## Errata Sheet

December 23, 1998 / Release 1.1

<b>Device:</b>	<b>SAB 83C166-5M</b> <b>SAB 83C166-5M-T3</b> <b>SAB 83C166-5M-T4</b> <b>SAB 80C166-M</b> <b>SAB 80C166-M-T3</b> <b>SAB 80C166-M-T4</b>
<b>Stepping Code / Marking:</b>	<b>ES-DC, DC</b>
<b>Package:</b>	<b>MQFP-100</b>

### **Problem 11: Input Leakage Current (I<sub>oz1</sub>) at Port 5**

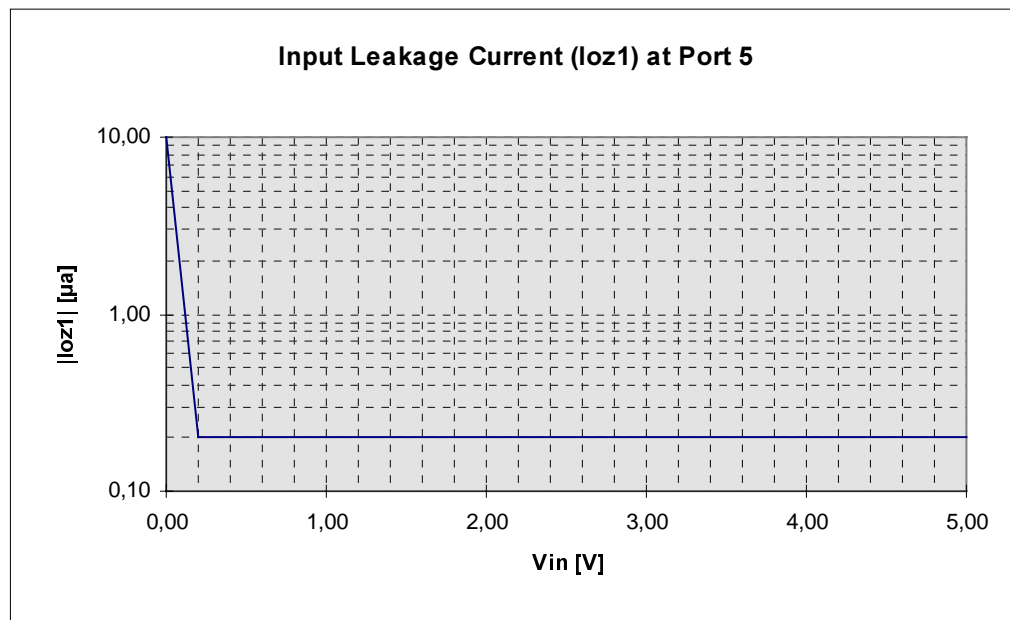
The input leakage current (I<sub>oz1</sub>) of some devices can deviate from the actual specified limit value of ±200 nA at input voltages (V<sub>in</sub>) close to 0 V. High ambient temperature and maximum supply voltage lead to a maximum increase of the leakage current.

The following equation describes the behavior of the leakage current for input voltages between 0 V and 200 mV and covers all specified operating conditions. This equation stands for an exponential decrease from ±10 µA leakage current at V<sub>in</sub> = 0 V to ±200 nA at V<sub>in</sub> = 200 mV.

Input Voltage (V <sub>in</sub> )	0 ≤ V <sub>in</sub> ≤ 200 mV	200 mV ≤ V <sub>in</sub> ≤ V <sub>cc</sub> <sup>1)</sup>
Input Leakage Current (I <sub>oz1</sub> )	I <sub>oz1</sub> = ±a·e(b·V <sub>in</sub> ) a = 10 µA; b = -0,0196 mV <sup>-1</sup>	I <sub>oz1</sub> = ±200 nA

<sup>1)</sup> **Note:** For input voltages above 200 mV the input leakage specification remains unchanged.
